Re: Response to John Clarke Comments dated 03/07/2019, Lanc & Tully Comments dated 03/08/2019, NYSDOT comments dated 03/21/2019, and Public Comments at 03/12/2019 Public Hearing 248 Beacon Holdings LLC - Fishkill Creek Development Concept Plan for 248 Tioronda Avenue (Formerly Beacon 248 Development, LLC, Multifamily Development) 248 Tioronda Avenue, City of Beacon, Dutchess County, NY Chazen Project #81750.00

The following is a point-by-point response to the above referenced comments.

ENVIRONMENTAL CONDITIONS/CONSTRAINTS

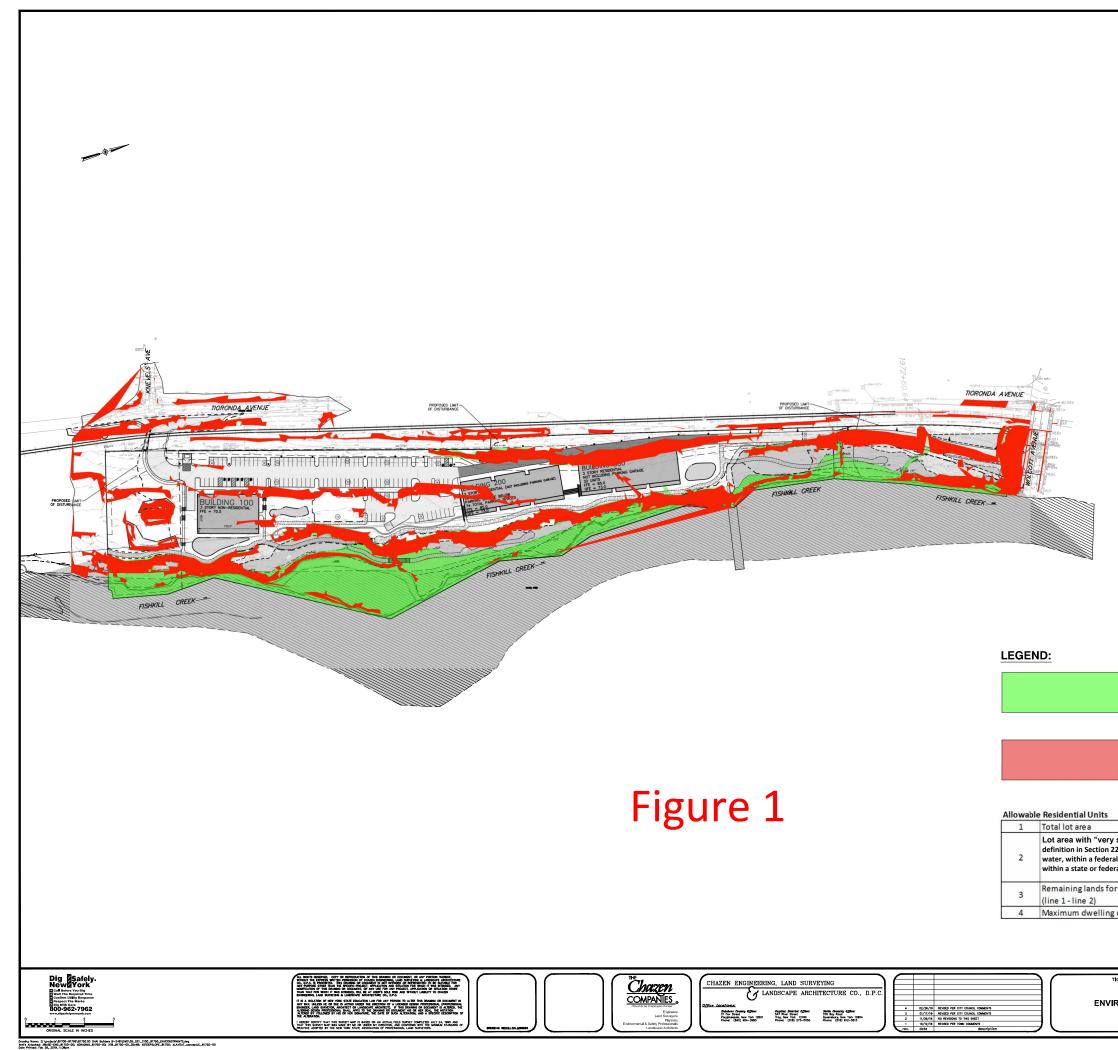
1. A justification that Section 223-16 B regarding very steep slopes is satisfied to the maximum degree feasible will be needed for a SEQR determination.

Response: The "very steep slopes" (per the definition in Section 223-81) along Fishkill Creek have been substantially avoided with both the development and Greenway Trail Layout. Internal steep slopes are used in the site plan concept design to transition grade between the upper (west side) and lower (east side) of the site. The emergency access road going out to Wolcott, uses wall to transition between grades. Please refer to Figure 1 attached.

Figure 2 Access Drive from Previously Approved Plan

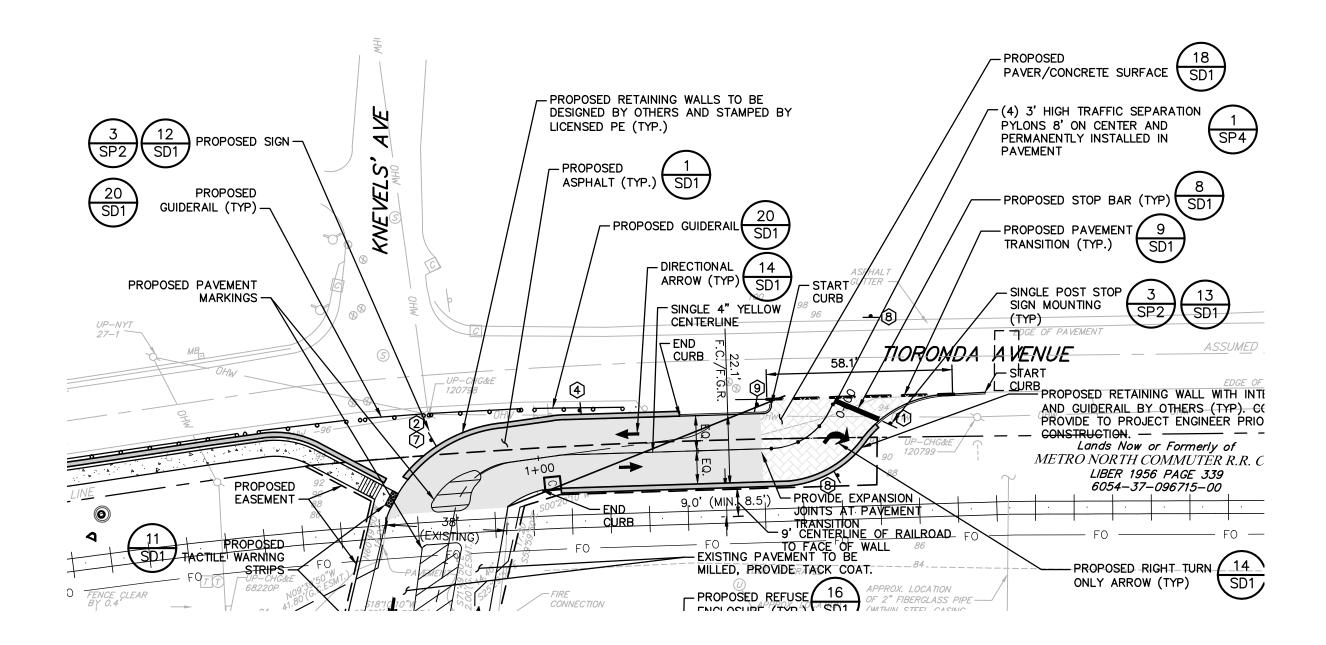
6. Noted Knevels Ave steep grade going down into Tioronda Ave.

Response: As part of the previous site plan approval, a guide rail is proposed on the east side of Tioronda Ave directly across from Knevels Ave. Please refer to Figure 2 attached.
